**47 Johnston Road, Mossman Gorge, MCU (Retirement Facility)  
Information request response (pursuant to Section 13 of the Development Assessment Rules)  
Your Ref: MCUC 2023\_5532/1**

### **Information Request Response - 47 Johnston Road, Mossman .**

**Extract of 1% AEP Existing Case – Depth – Marris Creek Flood Study and Levee Design**

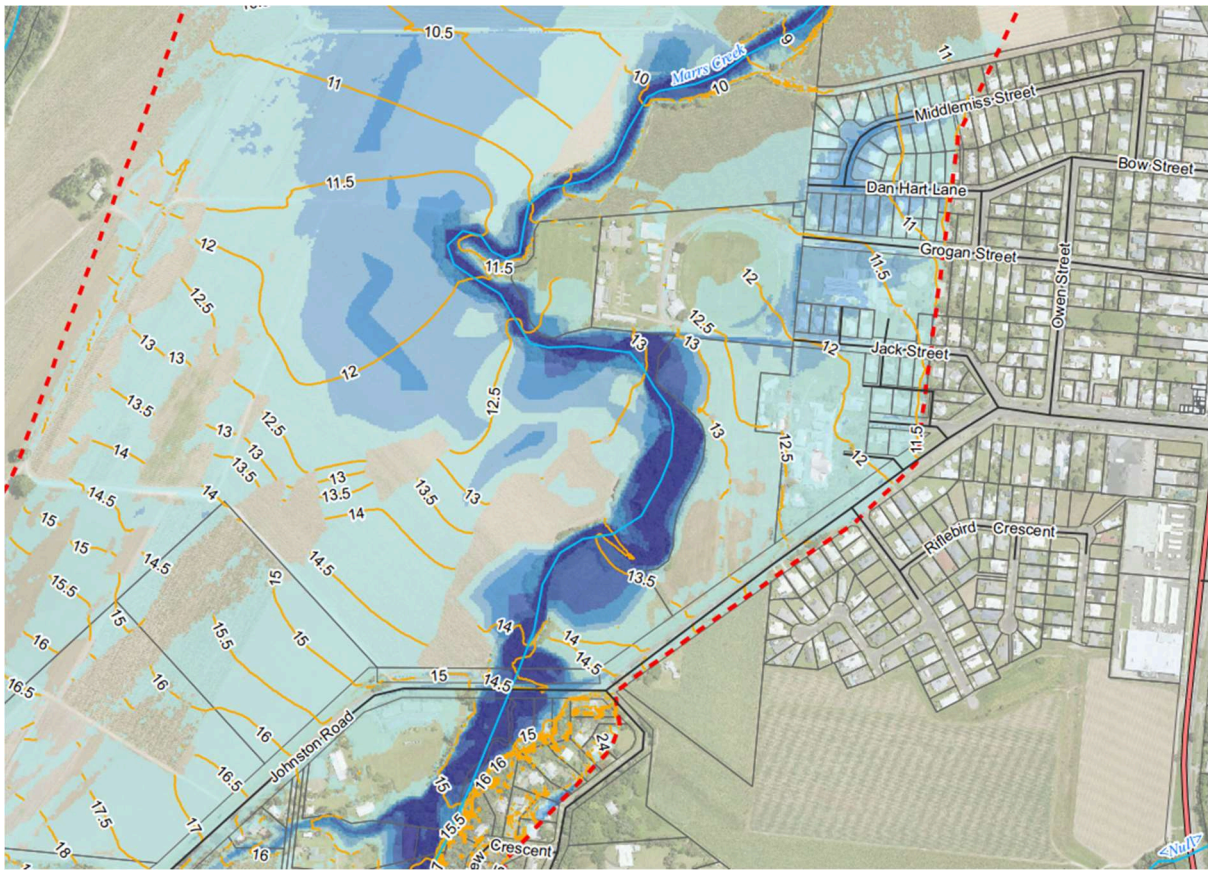
*b. The extent of the 100 year ARI flood event in relation to the site both pre- and post-development, including Lot 149 on SR587 (Mossman Hospital) and Lot 92 on SR81 (Showgrounds);*

The extent of flooding will be a combination of the GHD flood report extents as the southern half of the bund will be constructed however Marris Creek will still overtop from the northern boundary of this site and the Showgrounds and flood towards Mossman.

It is expected that this development and the bund will reduce the flooding to the hospital and south of Jack Street but flooding will still impact the showground and north of Jack Street. Areas of the Marris Creek top of bank north of the bund extension which are below RL 13m will overtop.

TURN PATH ASSESSMENT  
OVERALL PLAN

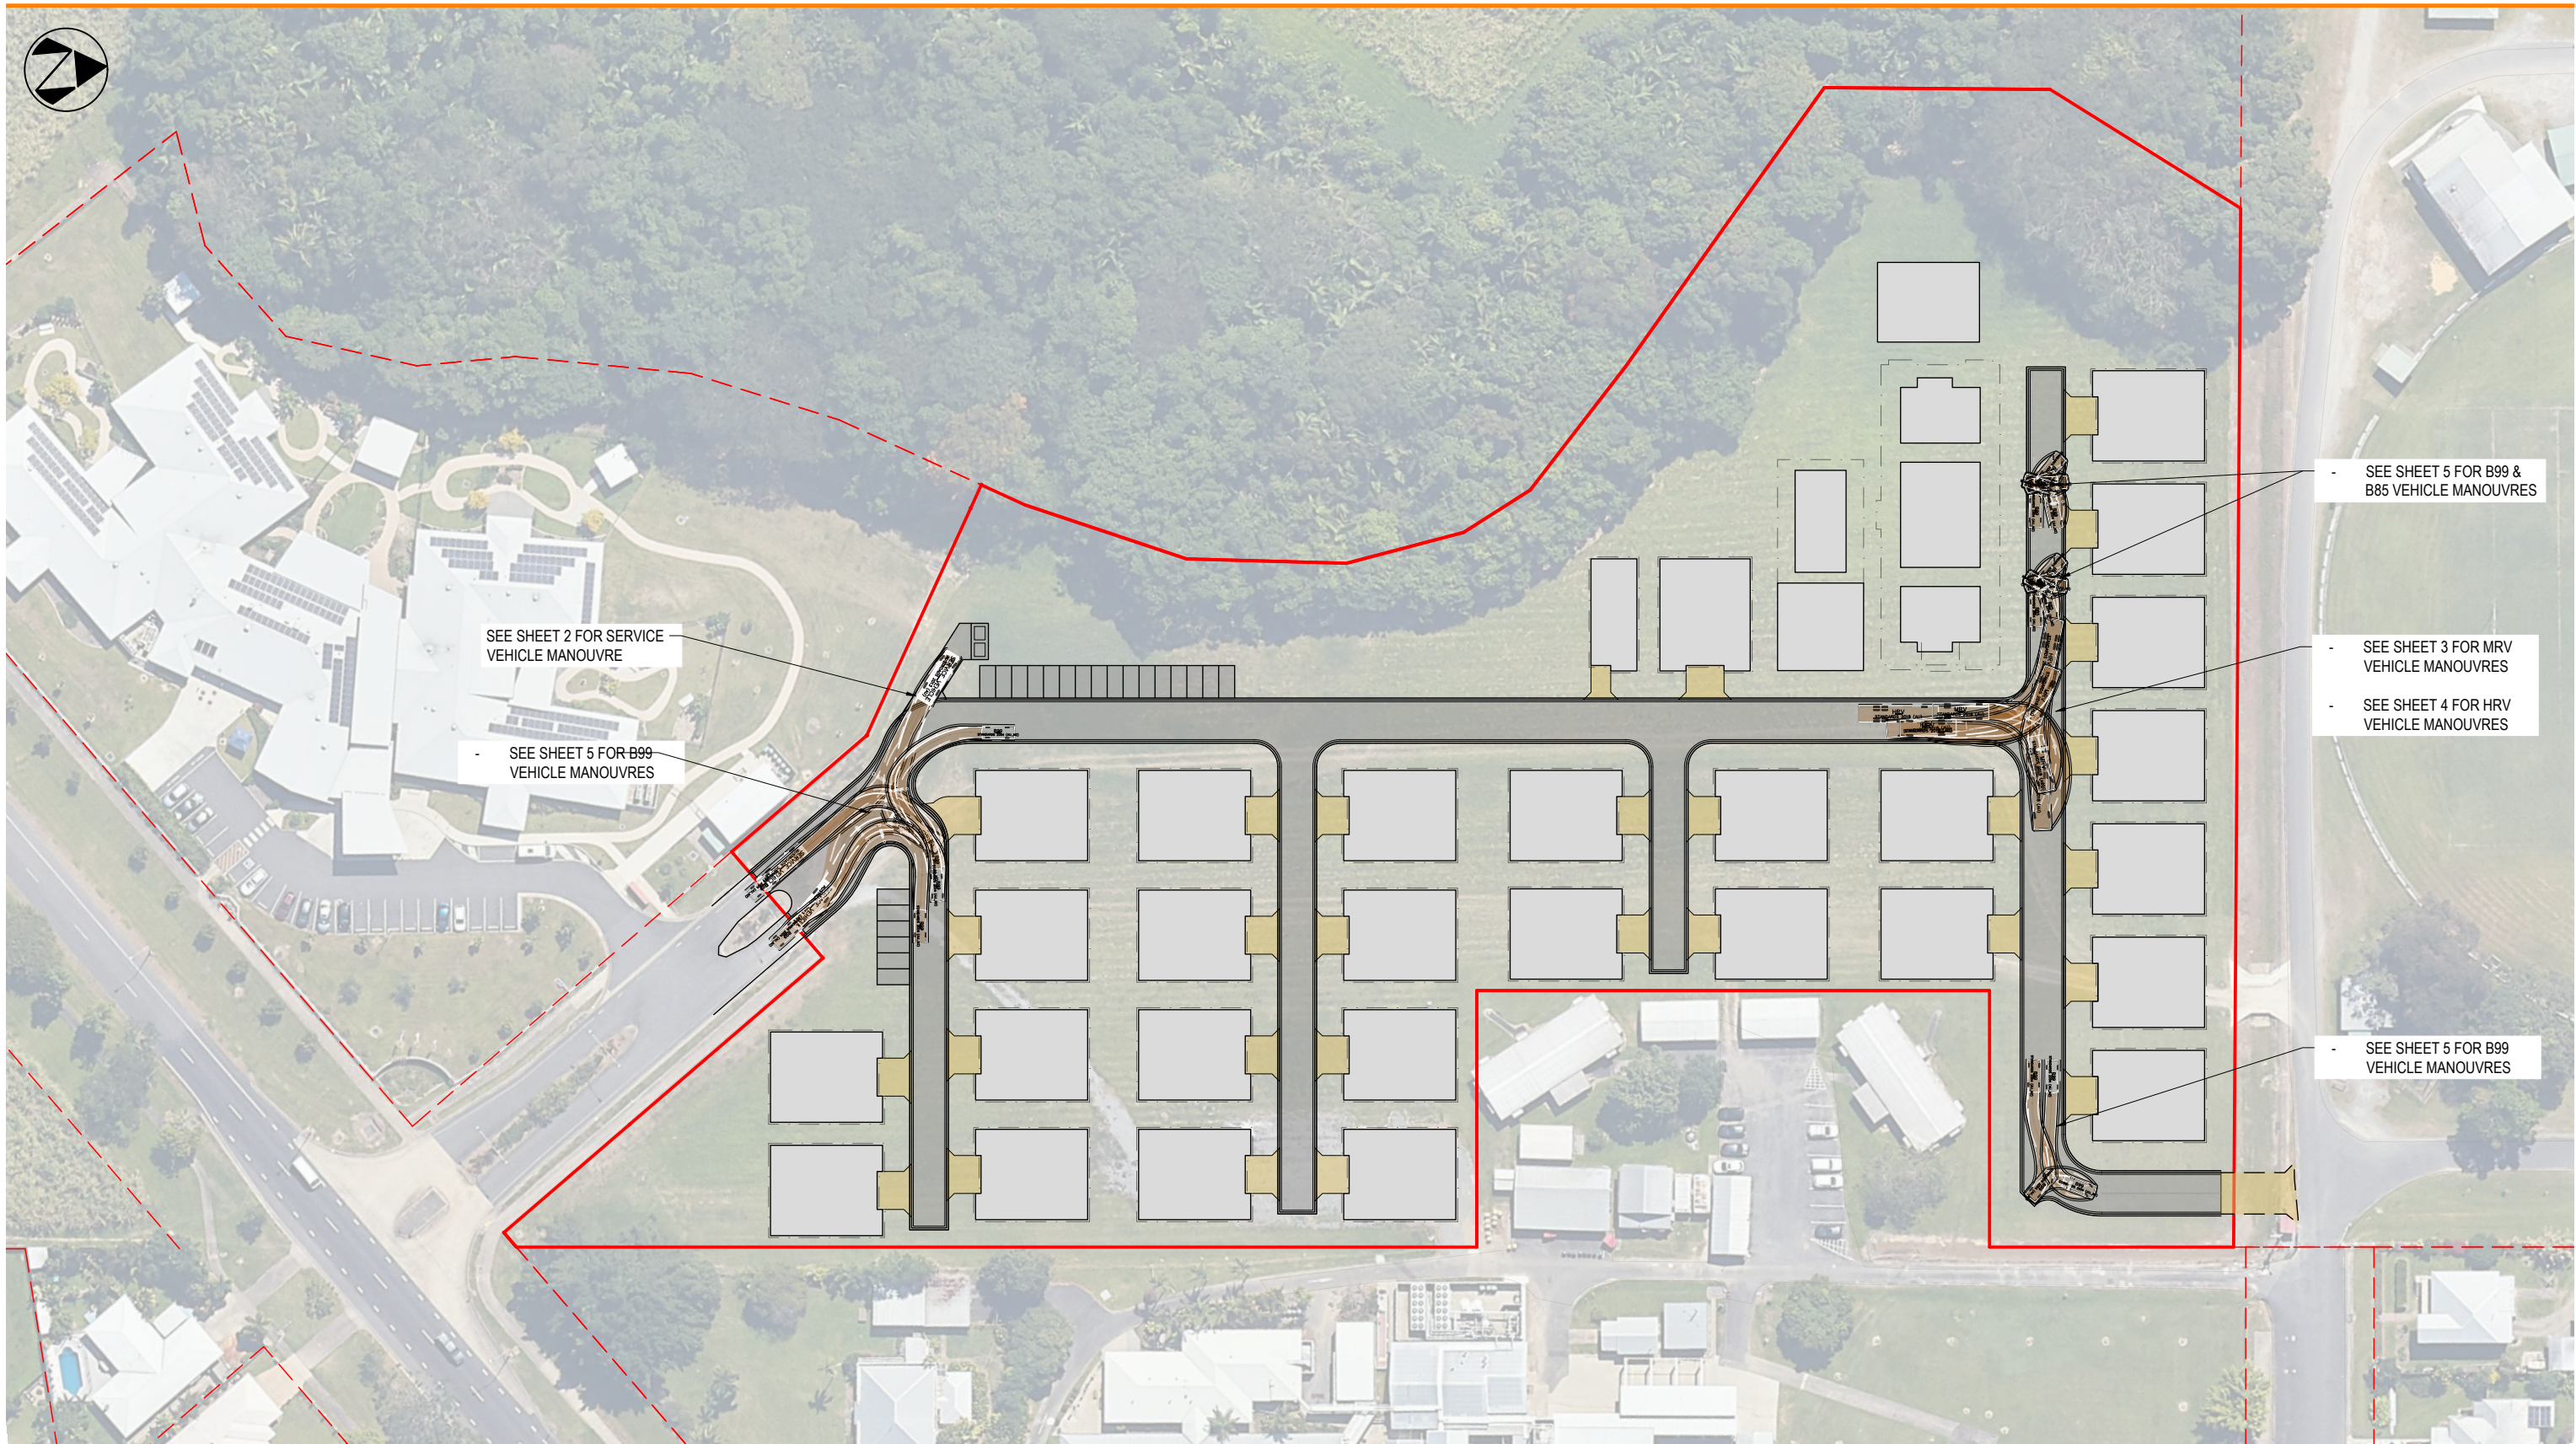
- 3. The Applicant is requested to assess whether a 6.0 metre minimum radius of curvature for the through road for the inside kerb line at the bend into the east west road and at the inside kerb line for the bend to the potential Jack Street/showgrounds can be provided*

- 4. Concerns are raised regarding the 3.0 metre radius of curvature in the vicinity of the most southern internal road stub. The Applicant is requested to amend the engineering plan(s) to increase the kerb radius to a practical turning circle width*

Additional curvature has been provided to the inside bends of the road in the attached plans. Turn paths of design vehicles are also included.

Additional curvature has been provided to the inside bends of the road in the attached plans. Turn paths of design vehicles are also included.

TURN PATH ASSESSMENT  
SERVICE VEHICLE - REFUSE STORE

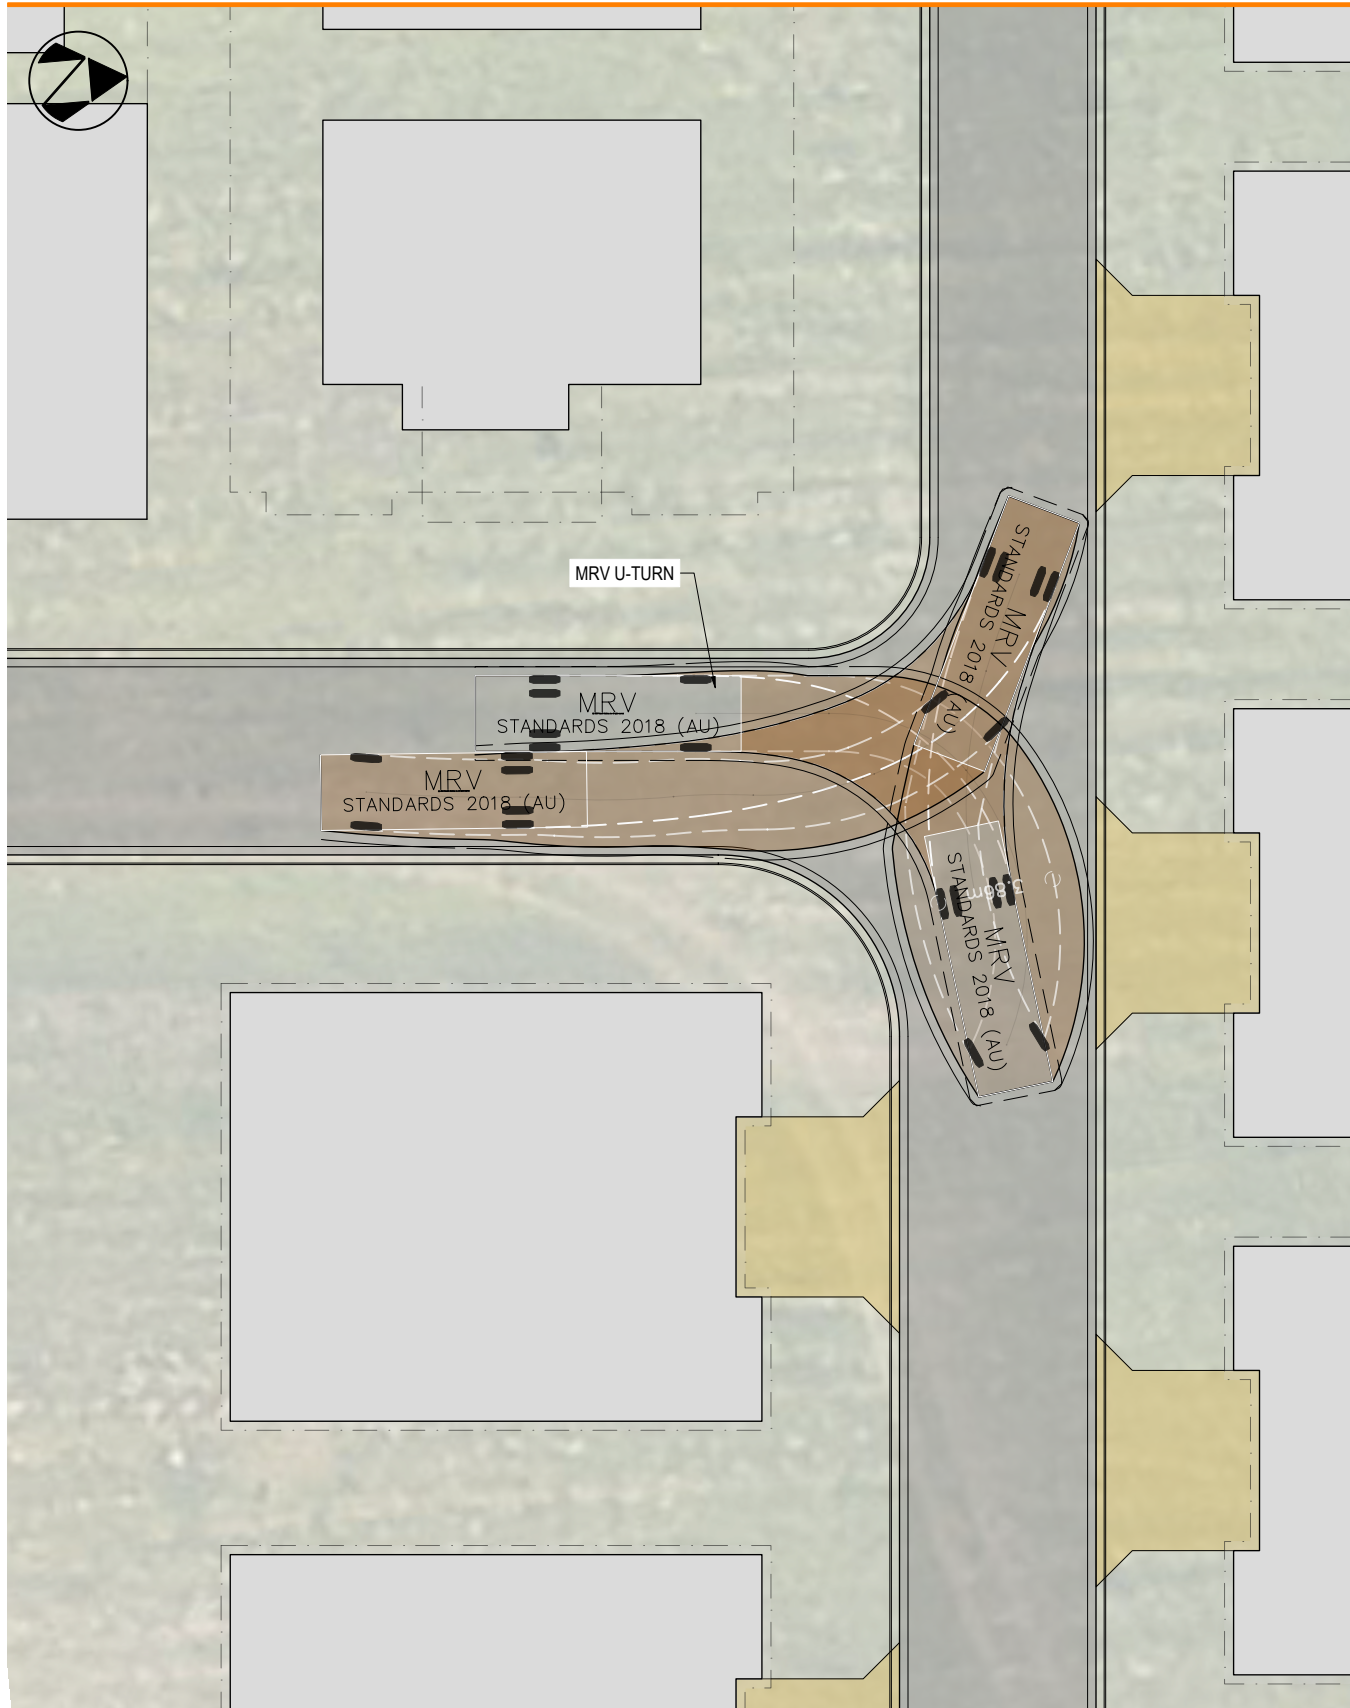
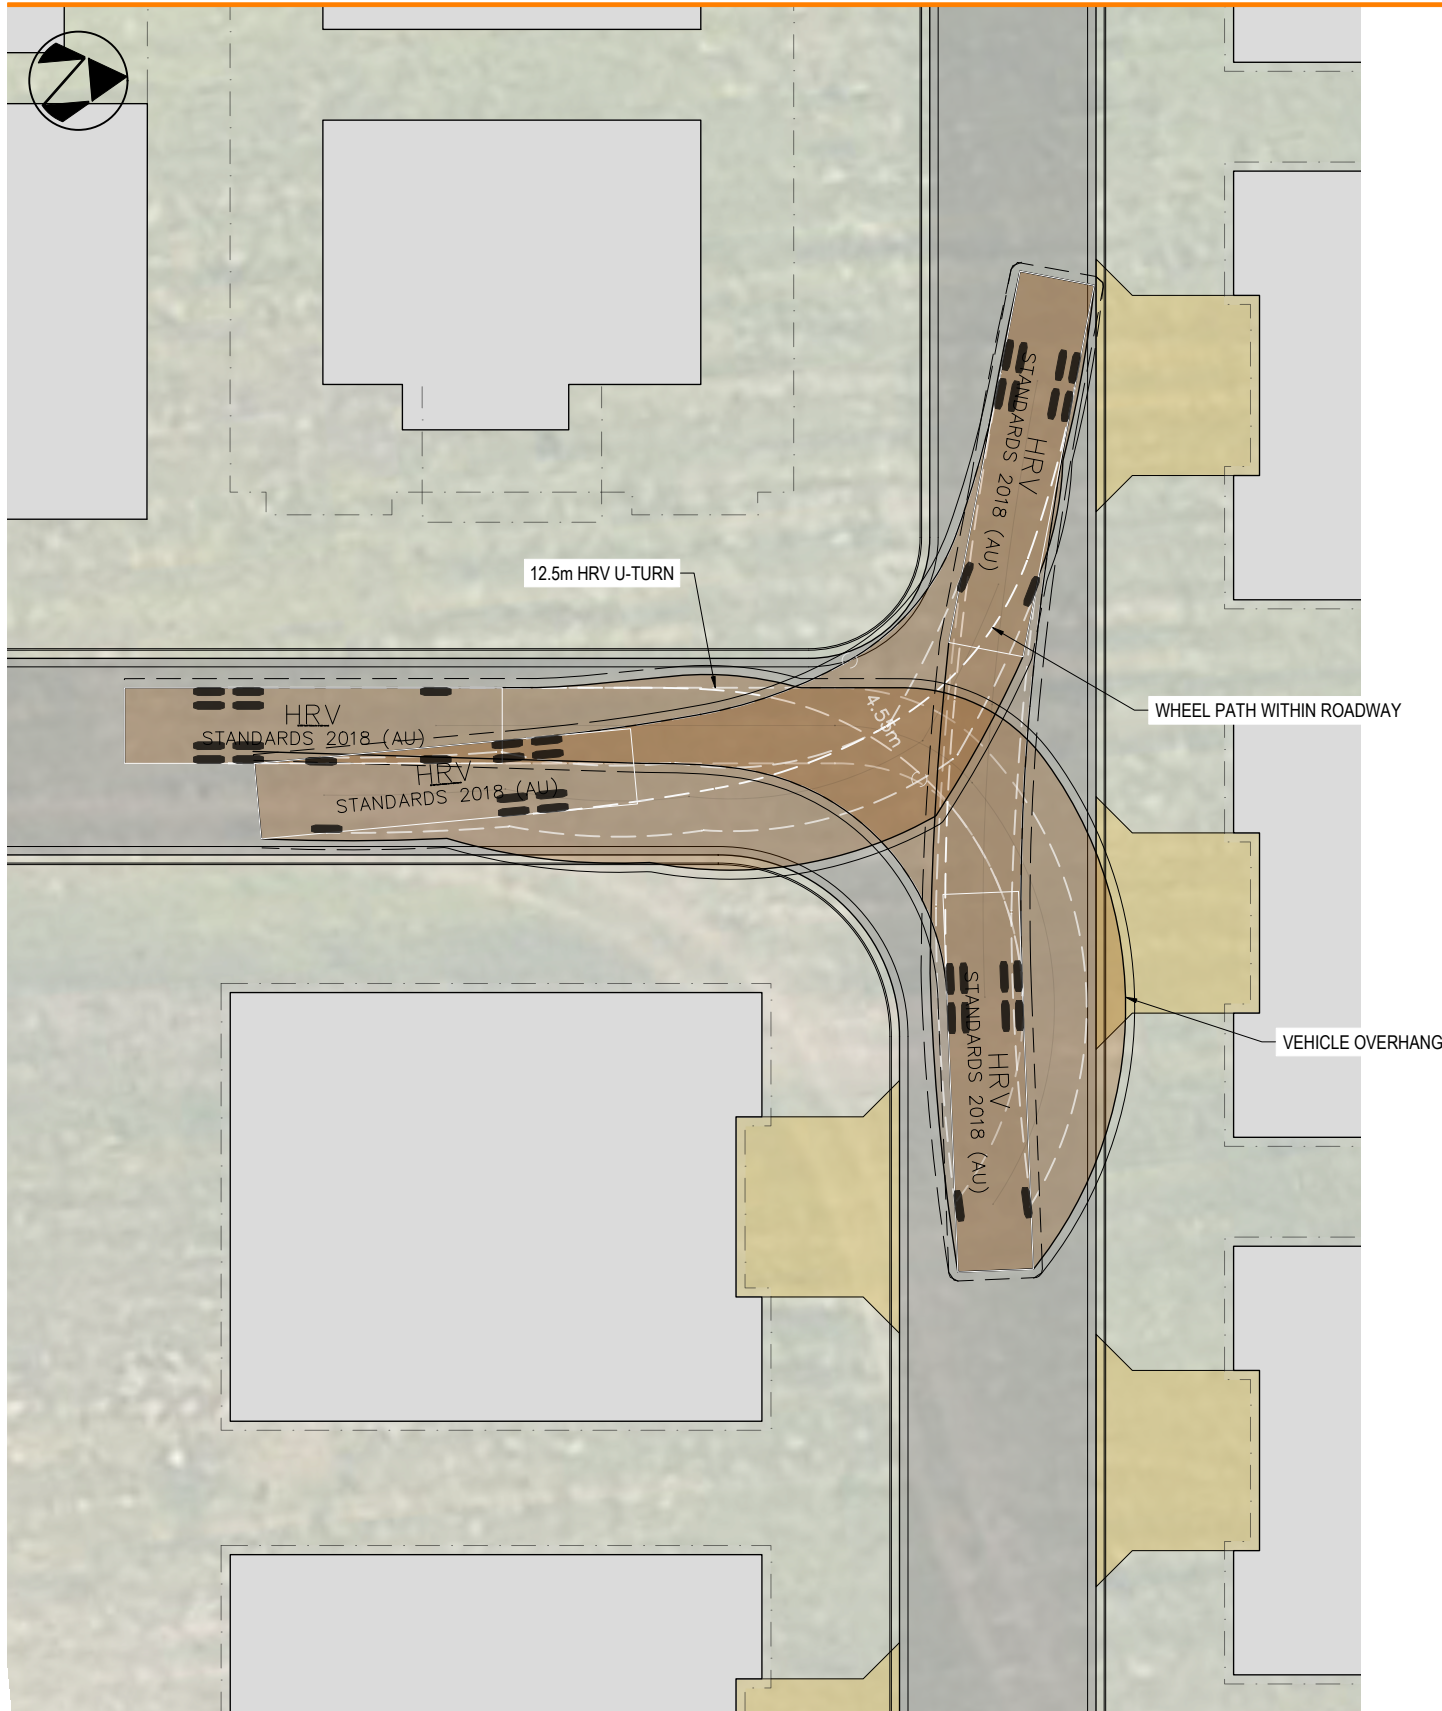
Amend the plans to enable a B99 design vehicle can turn-around at the end of all proposed road stubs without relying on driveways servicing the dwelling units. Vehicles performing a 3 point turn would be acceptable.

7. *Amend the plans to enable a B99 design vehicle can turn-around at the end of all proposed road stubs without relying on driveways servicing the dwelling units. Vehicles performing a 3 point turn would be acceptable.*

Additional pavement has been provided to the inside bends of the road in the attached plans. Turn paths of design vehicles are also included.
